HISTORIC AND DESIGN REVIEW COMMISSION

Agenda Item No: 24

HDRC CASE NO: 2016-223
COMMON NAME: 623 Hemisfair Blvd
ADDRESS: 434 S ALAMO ST
LEGAL DESCRIPTION: NCB 13814 BLK 3 LOT SW IRR 416.30FT OF 12
NCB 13814 BLK 3 LOT PT OF 12 ARB 12L
ZONING: D H HE RIO-3, D H RIO-3
CITY COUNCIL DIST.: 1
DISTRICT: Hemisfair Historic District
APPLICANT: David Adelman/AREA Real Estate
OWNER: Omar Gonzalez/Hemisfair Park Public Facilities Corporation
TYPE OF WORK: Conceptual approval of new construction
REQUEST:

The applicant is requesting conceptual approval to construct a 150-unit apartment structure and a 415 space parking garage at 623 Hemisfair Blvd

LOCATION MAP AND SITE PLAN

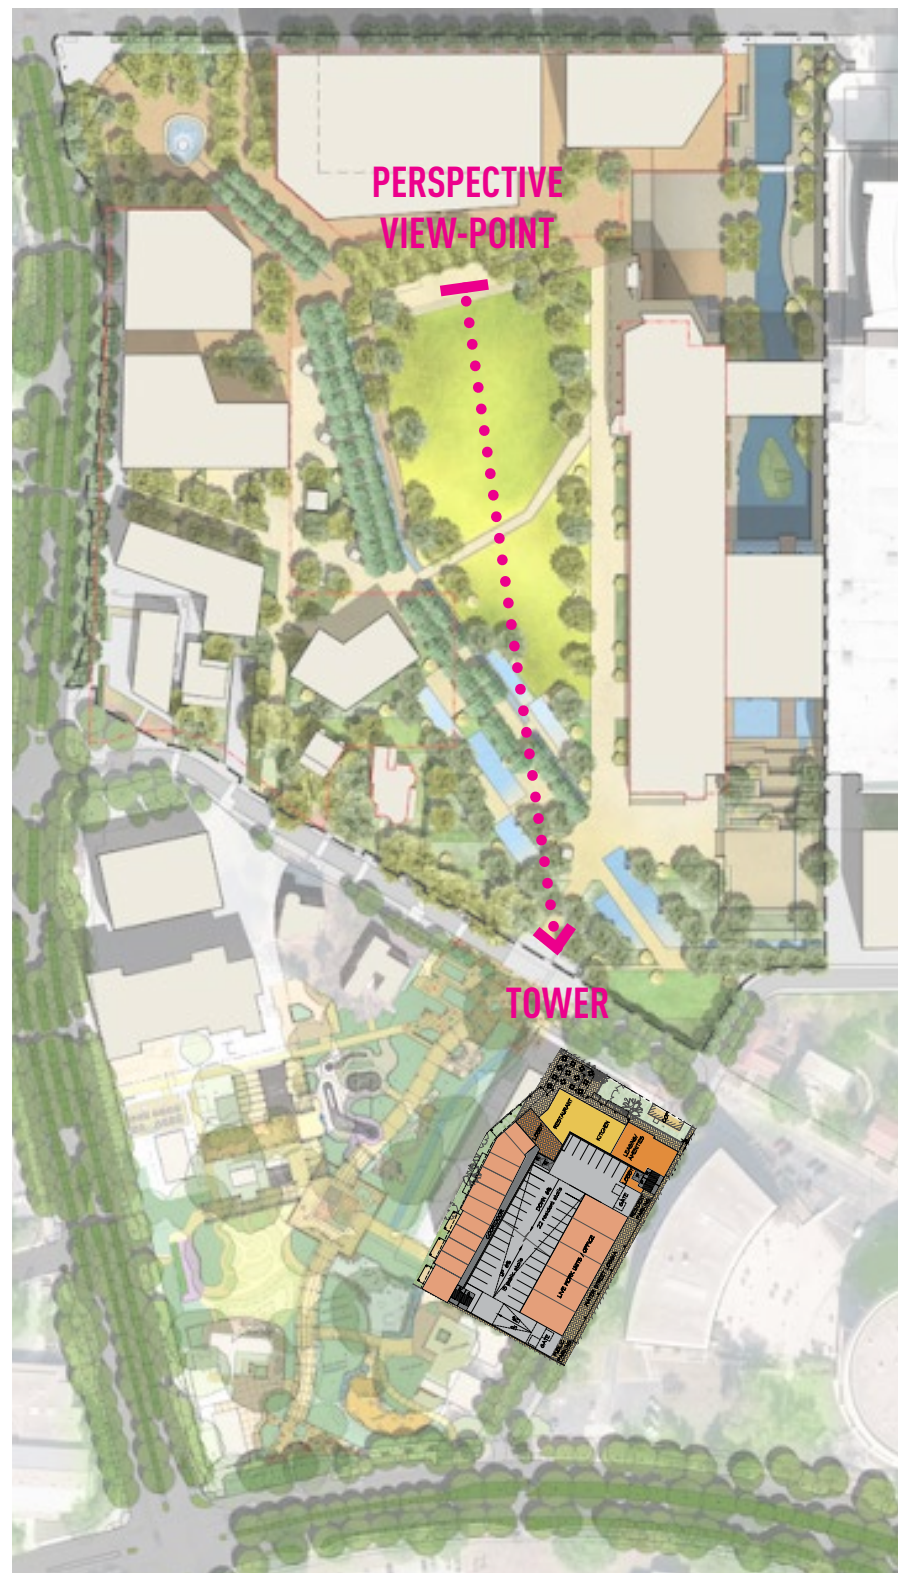
- b. This request was reviewed by the Design Review Committee on April 12, 2016, where comments focused on the proposed materials,
- c. PEDESTRIAN CIRCULATION – Per the UDC Section 35-672(a) in regards to pedestrian circulation, an applicant shall provide pedestrian access among properties to integrate neighborhoods. The applicant has provided a site plan noting the proposed new construction's connection with the various other pedestrian paths throughout Hemisfair Park. This is consistent with the UDC.

- u. **ACEQUIA** – The applicant has noted the location of the Acequia Madre de Valero in the provided application documents, however, staff recommends the applicant provide additional information regarding its inclusion into the overall design of the proposed new construction.

- i. That the applicant provide an updated site plan noting the widths of each curb cut as noted in finding d and the location of bicycle parking as noted in finding l.
- ii. That the applicant provide updated information regarding proposed plant materials as noted in finding h.
- iii. That the applicant provide updated information regarding proposed site furnishings as noted in finding i.
- iv. That the applicant provide information on the location and screening of all mechanical equipment.
- v. That the applicant provide information in regards to site and architectural lighting as noted in finding j.
- vi. That the applicant provide information on how the impact of the new construction's dwarfing of the Smith House will be mitigated.

WEST ELEVATION

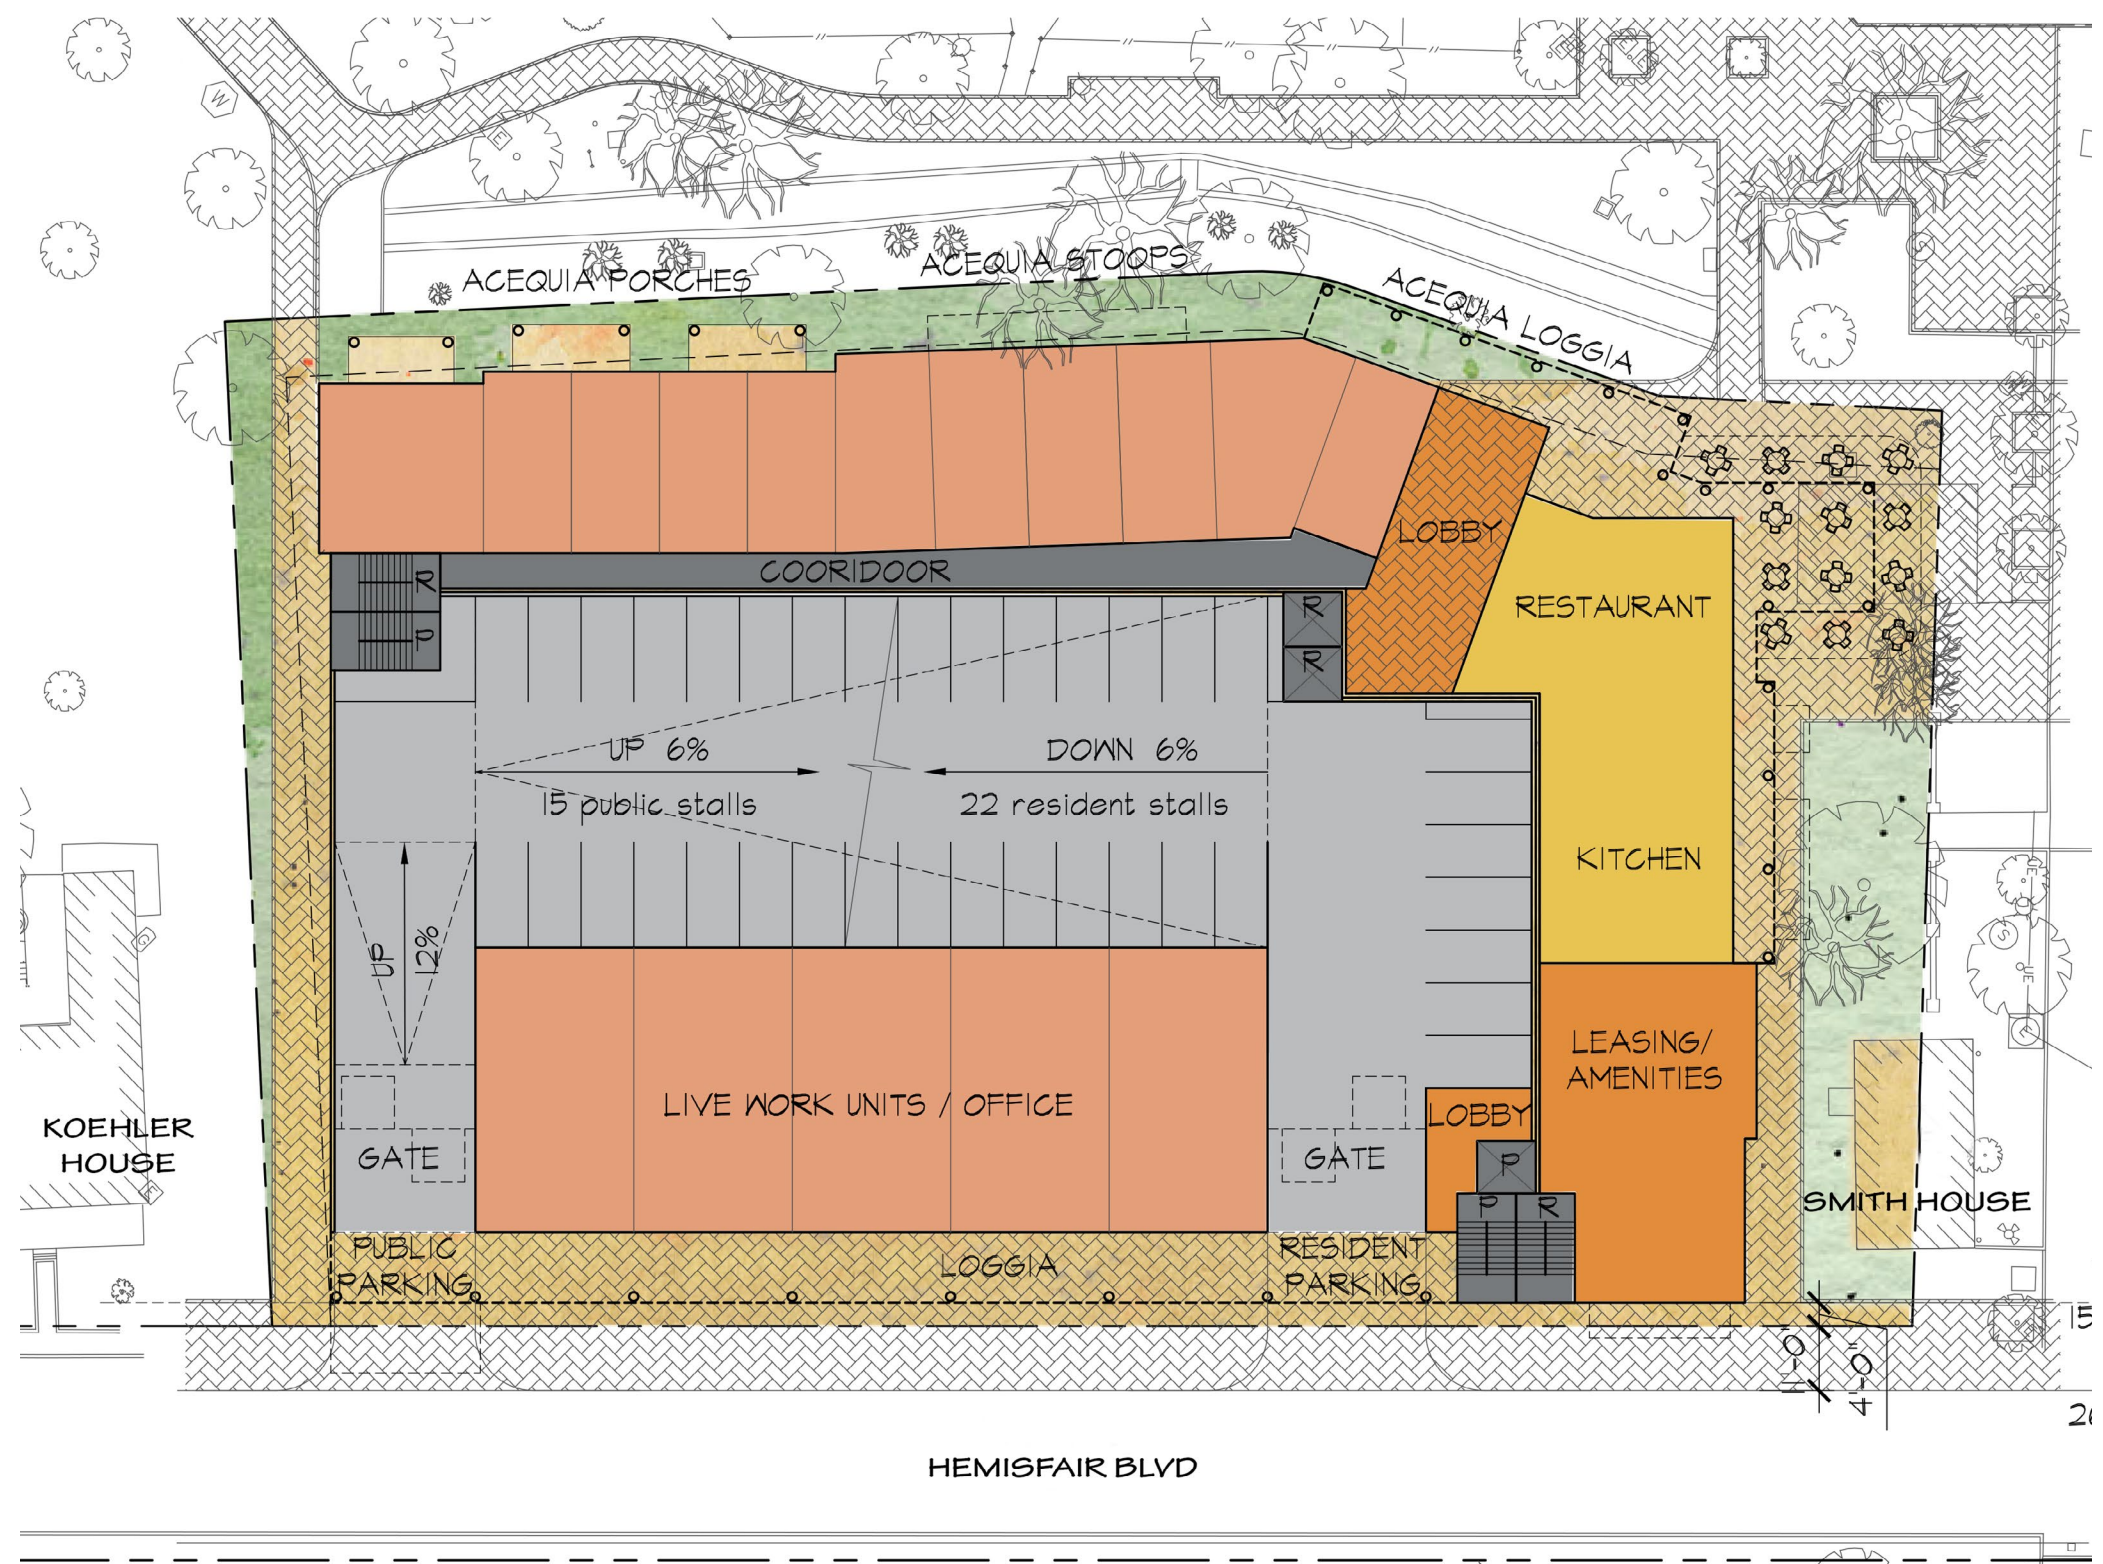
- t. **SOLAR PANELS** – The applicant has proposed to mount PV panels to the roof of the parking structure which will also provide shading elements for automobiles. The applicant has proposed to screen the view of the PV panels from the south by the proposed metal screening and vegetative elements. Staff finds this appropriate and the screening of the PV panels consistent with the UDC Section 35-673 (m).

The tower element is a terminus to the esplanade and a focal point from the great lawn
